IEEE 802.11

Define the IFS's: Update to Section 5.2.4 & 5.2.13

Abstract: This paper describes the changes in section 5.2.4 and section 5.2.13 to reflect the proposed SIFS, PIFS and DIFS definitions as presented in Doc IEEE 802.11-95/86a.

New Figure to illustrate IFS relations Fig 5-6.

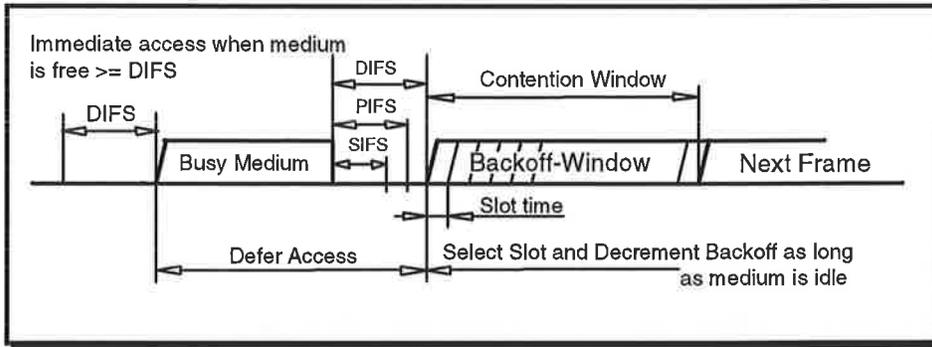
Changes to section 5.2.4:**0.0.1. Inter-Frame Space (IFS)**

The time interval between frames is called the inter-frame space. A STA shall determine that the medium is free through the use of the carrier sense function for the interval specified. Three different IFS's are defined so as to provide a corresponding number of priority levels for access to the wireless media. The following three different IFSs are defined:

It should be noticed that the different IFSs are independent of the station bitrate, and are fixed per each PHY (even in multi-rate capable PHYs),

The IFS timings are defined as time gaps on the medium. The standard shall specify the relation of the relative PHY MIB parameters to achieve the specified timegaps as further specified in section 5.2.13. ~~The timing tolerances are specified in an explanatory section of the MIB.~~

Fig 5-14

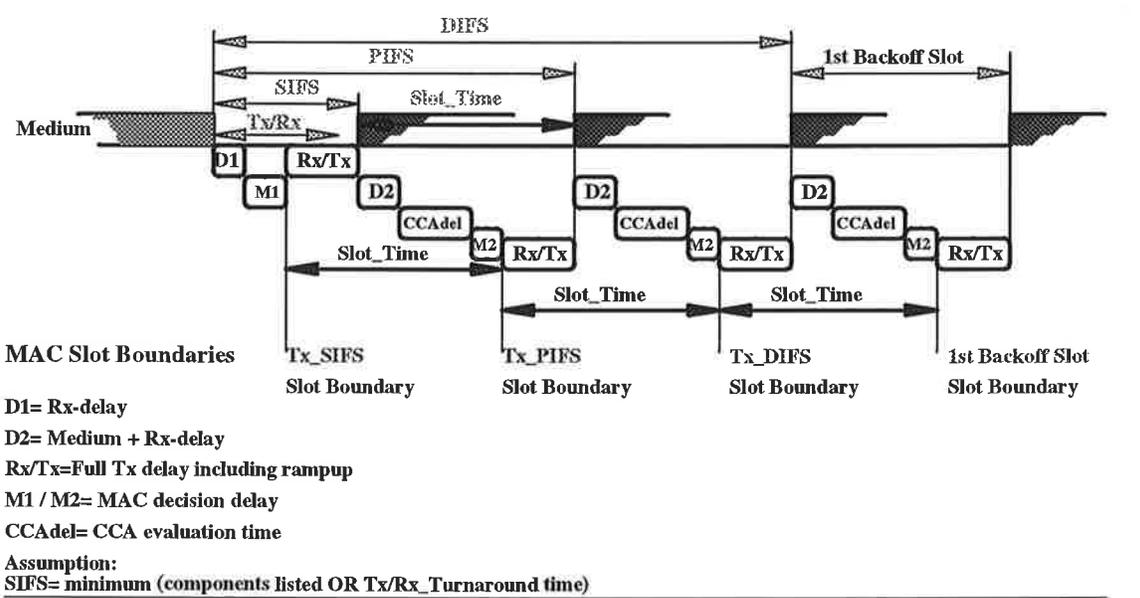
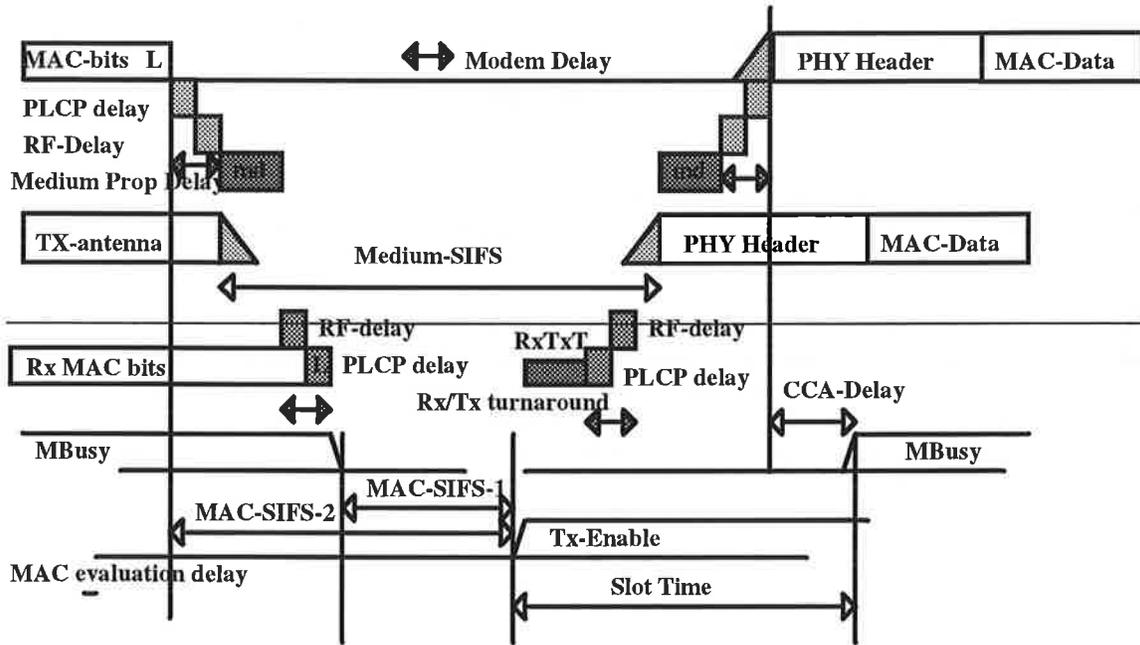
0.0.4.DCF Timing Relations

This section formulates the relation between the IFS specifications as have been defined as time gaps on the medium, and the associated MIB variables that are provided per PHY.

All timings are referenced to the end of the last symbol of a frame on the medium.

The SIFS, and Slot Time are defined in the MIB, and are fixed per PHY.

SIFS is based on: Rx Delay + MAC Delay-1 + Rx/Tx Delay.

Slot Time is based on: Rx/Tx Delay + Medium Delay + Rx Delay + CCA Delay + MAC Delay-2

The PIFS and DIFS are derived by the following equations, as illustrated in figure 5-14.

PIFS = SIFS + Slot Time

DIFS = SIFS + 2 * Slot Time

The Medium Delay component is fixed at 1 usec.

Figure 5-14 illustrates the relation between the SIFS, PIFS and DIFS as they are measured on the medium and the different MAC Slot Boundaries Tx SIFS, Tx PIFS and Tx DIFS. These Slot Boundaries define when the transmitter can be turned on by the MAC to meet the different IFS timings on the medium, after subsequent detection of the CCA result of the previous Slot Time.

The following equations define the MAC Slot Boundaries, using parameters defined in the MIB, which are such that they compensate for implementation timing variations. The reference of these slot boundaries is again the end of the last symbol of the previous frame on the medium.

Tx SIFS = SIFS - a Rx/Tx Turnaround Time (MIB variable)

Tx PIFS = Tx SIFS + Slot Time

Tx DIFS = Tx SIFS + 2 * Slot Time.

The tolerances are specified in the MIB, and will only apply to the SIFS specification, so that tolerances will not accumulate.
